STAFF RECOMMENDATION

NCPC File No. 5907

MARTIN LUTHER KING, JR. NATIONAL MEMORIAL
TIDAL BASIN, WEST POTOMAC PARK
Washington, D.C.

July 3, 2008

PRELIMINARY SITE AND BUILDING PLAN OF VISITOR CONTACT BOOKSTORE/RESTROOM BUILDING

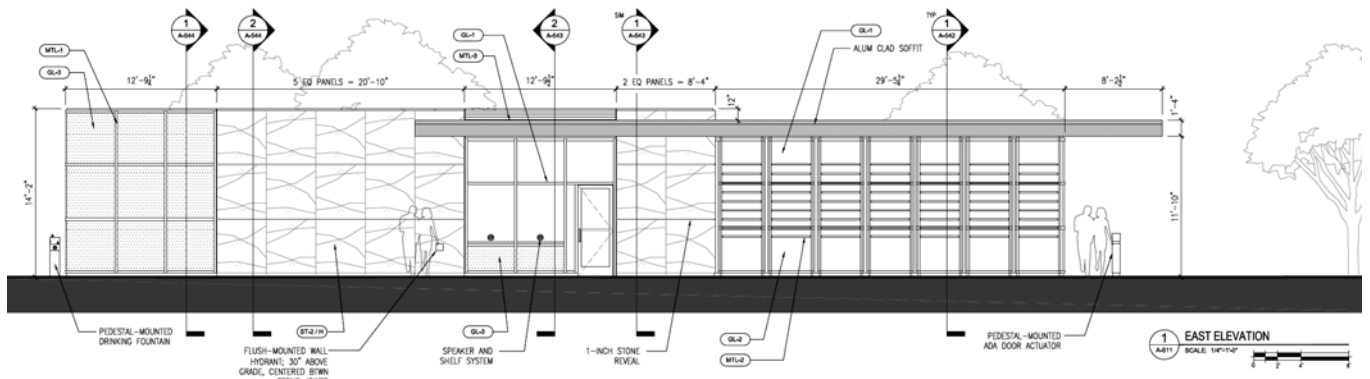
Staff is pleased with the progress and preliminary design of the Martin Luther King, Jr. National Memorial. The design details included in the preliminary design for the building and many memorial features are highly refined and clearly noted. Furthermore, staff finds the preliminary design of the Visitor Contact/Bookstore/Restroom Building is light and simple in its material composition; subdued in its massing; and is appropriately located to best serve the memorial's visitors.

Approves the preliminary site and building plans for the memorial's Visitor Contact Station/Bookstore/Restroom Building only, as shown on the NCPC Map File No. 1.51(73.10)-42570, and;
